Rego 100 display incl. CPU  Rego 1000 display

SP affected:

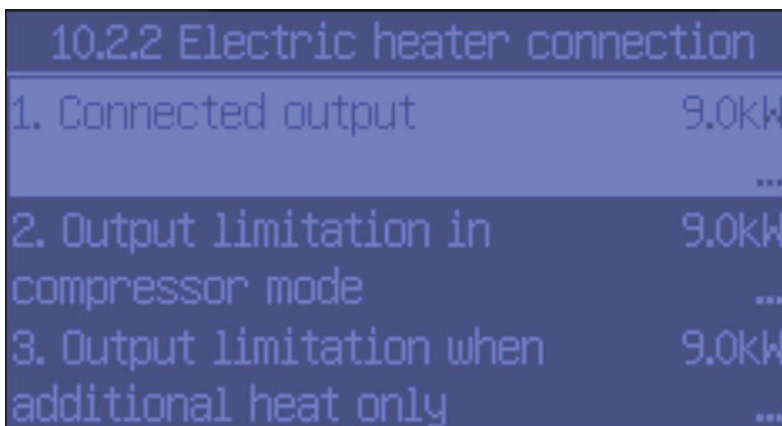
87382013930, CPU SW PCB

8738206946, Display IVT incl. CPU

Settings in Rego 1000 display after replacement:

L/W 14-17kW - no changes needed.

L/W 6-11kW - set acc. to below picture.
